Report of
Anthony R. Ingraffea, Ph.D., P.E.
on
Crestone's Final Comprehensive Development Plan for the Operation of the
Codell and Niobrara Formations, Wattenberg Field, Boulder County, Colorado

June 26, 2018

3.0 COMMENTS ON CRESTONE'S CDP

Figure 1. Proposed CDP at the westernmost edge of the Wattenberg Field has highest probability encountering faulting and increasing risk of induced seismicity.

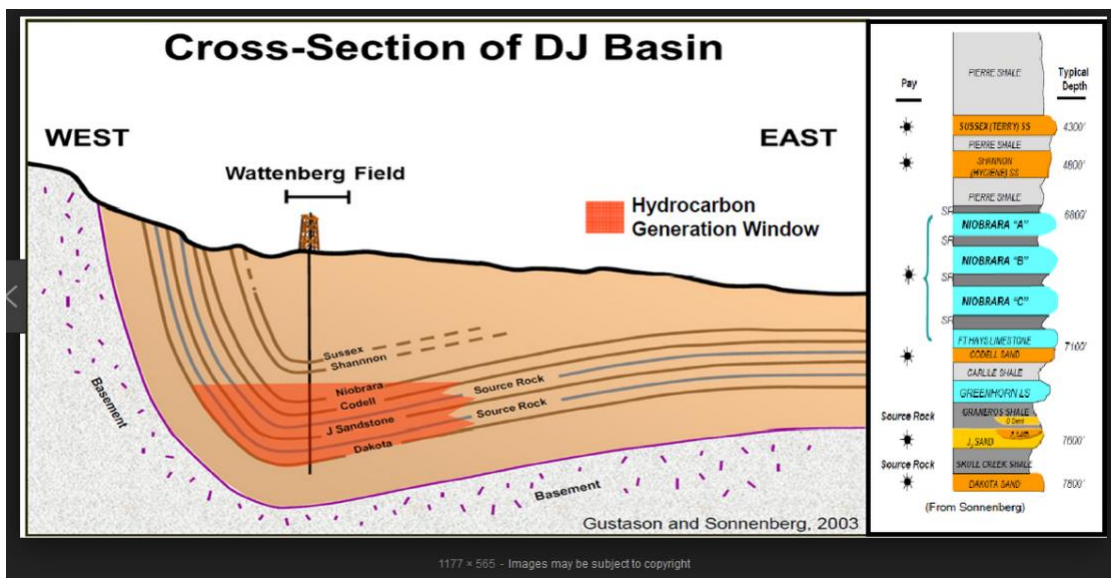
Will fully 3D seismic mapping be done in the CDP area? If yes, will Boulder County be provided with results and their interpretation to ascertain the likelihood of induced

seismicity from interaction with possibly identified faults. Will a qualified 3rd party be allowed to ascertain this likelihood? The density of the proposed development, 140 wells within about 10 square miles, and the injection of at least 1.4 billion gallons for fracking fluid requires that an assessment of potential induced seismicity be undertaken, especially because the proposed development is on the westernmost edge of the Wattenberg Field where probability of faulting is highest, Figure 1. Any significant (M_w greater than 4.0) induced seismicity creates risk of damage to above ground structures and personal injury, and damage to existing and proposed well structures and above-ground ancillary infrastructure. Damage to above or below ground structures could result in release of VOC's and methane to the atmosphere.

Figure 2. Proppant use trend by region. Note use of about 0.6 tons per foot of lateral in the Rockies region. <https://www.kimberliteresearch.com/single-post/2017/10/24/US-Oil-Gas-Industry-Reports-More-Proppant-Per-Lateral-Foot-Equates-to-Better-Completions>

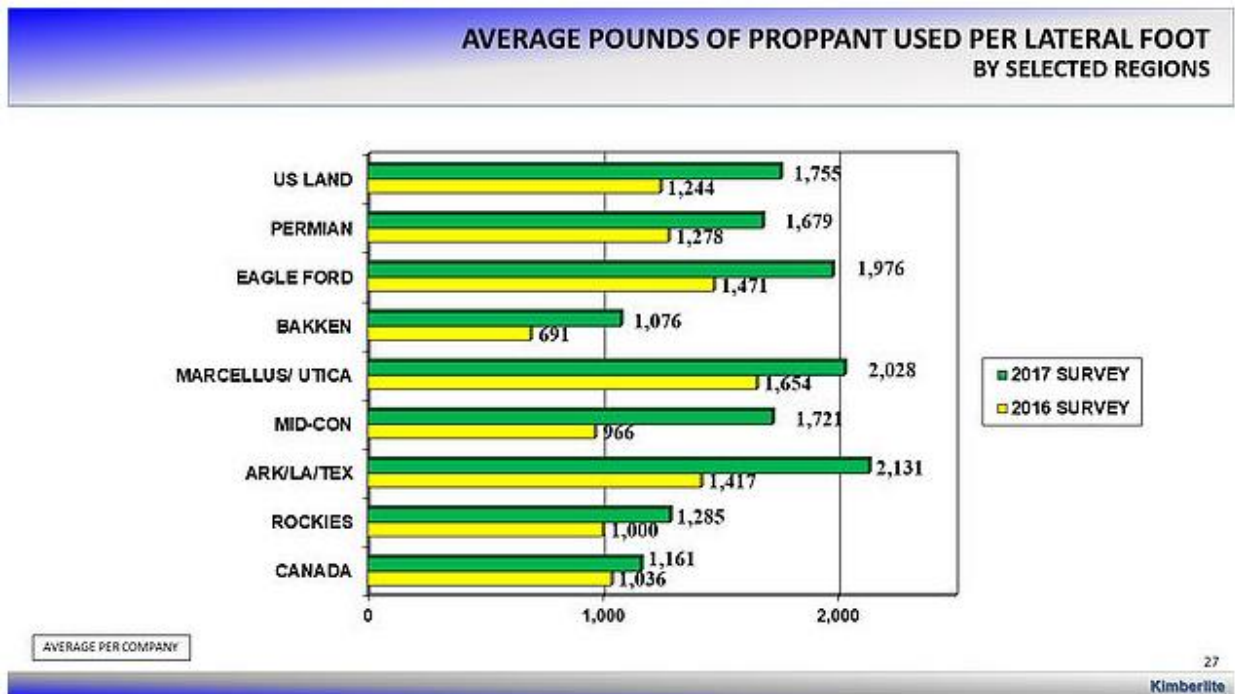
The scale of this proposed operation also means transport of about 1 million tons of sand to the three pads over a proposed period of 3.6 years, Figure 2 and Zborowski (2018). For comparison, that is a tonnage of sand equivalent to the weight of 10 of the largest nuclear aircraft carriers of the US Navy (https://www.naval-technology.com/features/feature-the-10-biggest-aircraft-carriers_4067861-4067861/). Crestone must state how many unit trains and truckloads will be required to transport this tonnage of sand to these proposed pads. A rough estimate, assuming 25 tons of sand per truck load, and 8,000 gallons per water/chemical tanker, is 40,000 sand truck deliveries, and 175,000 water/chemical truck deliveries, each trip emitting diesel pollutants.

Figure 5. Wells, producing, abandoned, and plugged and abandoned in the proposed CDP area. From www.bouldercounty.org/property-and-land/land-use/planning/oil-gas-development/#maps.

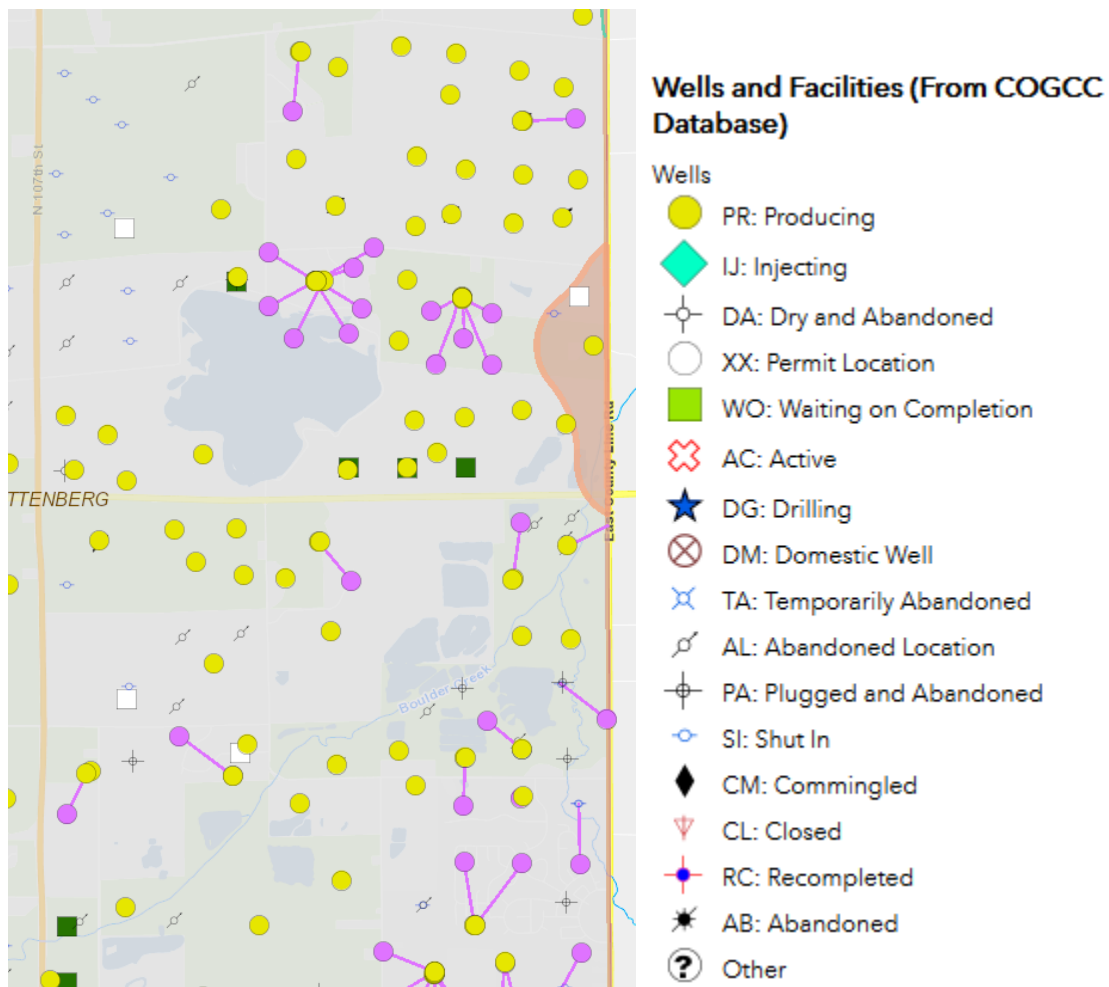
This is the first mention in the CDP about existing wells in the proposed development area. An engineering review of current producing wells cannot be considered a “benefit”. It is a mandatory process resulting from ongoing economic and regulatory activities. Given the increasingly heightened concern about “frac hits” in the industry (see for example, <https://www.denverpost.com/2018/03/08/berthoud-oil-spill-cause-report/>; 175 papers addressing the topic of “frac hits” have appeared in the industry archive, OnePetro, in the last 2 years) caused by high-density development (average lateral spacing among the 140 proposed wells is only about 150 feet) and increased use of frac fluid volumes (estimated 10 million gallons per well, see above), it is imperative that Crestone be required to evaluate the potential for “frac hits” among their proposed 140 wells and the existing 95 current producing wells, and ALL other non-producing wells in the CDP area, including possible abandoned and lost wells. This evaluation must follow the procedures declared in the COGCC’s “DJ Basin Horizontal Offset Policy, June 20, 2013” on all these wells. Failure to follow these mandatory procedures creates the risk of a frac hit that could result in a blowout through an existing well, and consequent impacts on the environment and human health from blowout materials which would include methane, VOC’s, BTEX materials, and frac fluid chemical additives.

Figure 5 shows known wells, producing, abandoned, and plugged and abandoned in the proposed CDP area. Note that there are a few dozen abandoned wells in the area, and that few, but not all, of these abandoned wells have been plugged. To emphasize the importance of this issue, Figure 6 overlays these wells on the “Conceptual Directional Wellbores Map” from the CDP. It is quite clear from this image that many existing wells of all types will be “near” many of the proposed laterals. This “nearness” must be evaluated for potential interaction for each existing well and nearby laterals. Note in particular that there are many existing wells in close proximity to single family residences and within, or in close proximity to, residential developments. For example, Figure 7 shows the surface locations of nine known wells within, or in close proximity to, the Kenosha Estates residential development in the southeast corner of the CDP area. Also shown are the spud dates and the maximum depth of these wells. The depths of all these wells are similar to the depths of the laterals proposed in the CDP.

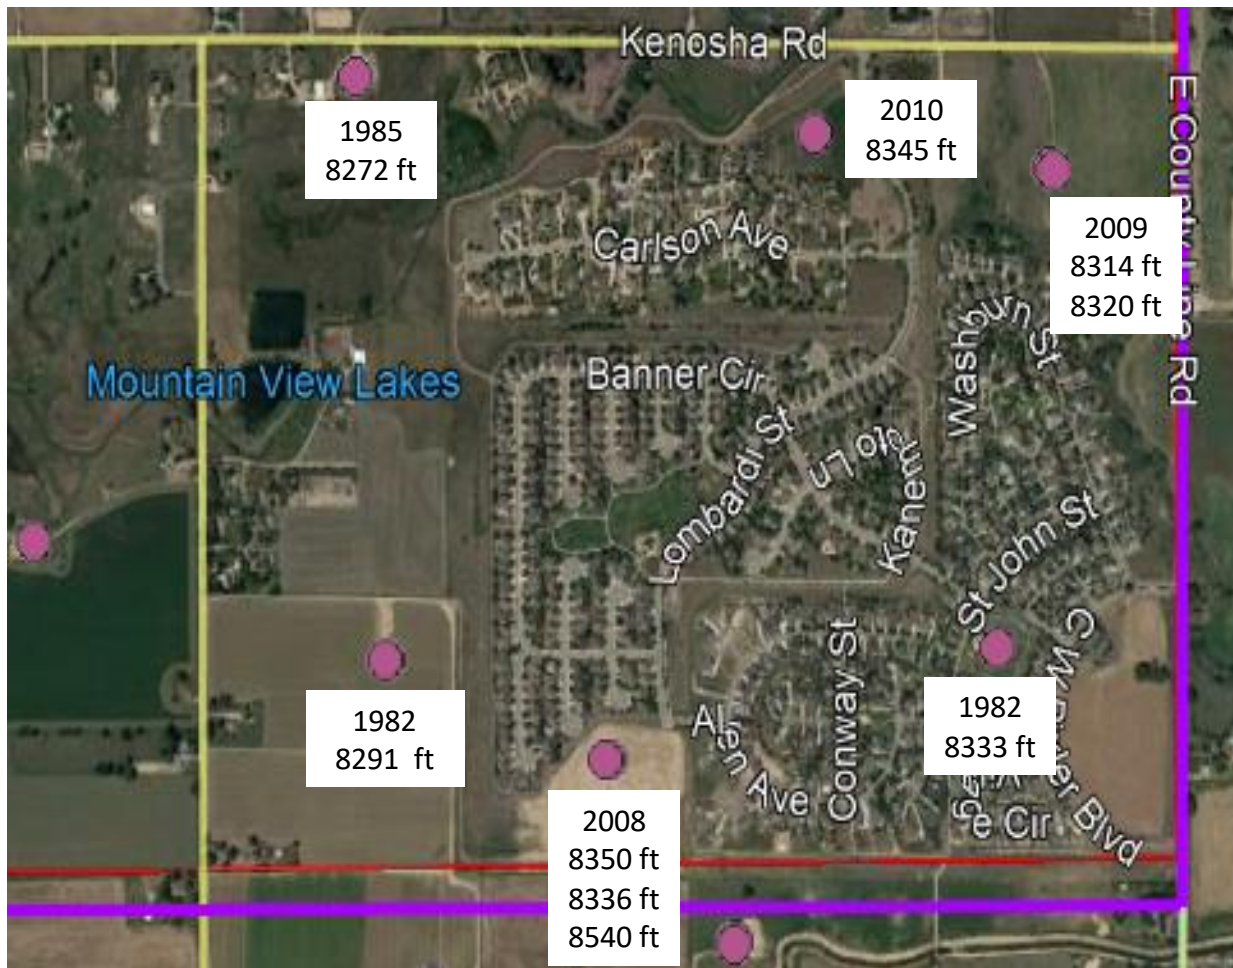
The spatial intensity of the proposed wells, with only about 150 feet of spacing between laterals, makes “frac hits” among them and with the many existing known and abandoned and unknown wells probable, with the possibility of blowouts with serious environmental and health impacts. Crestone’s plan to perform an “engineering review” of only the 95 producing wells in the CDP area is inadequate.
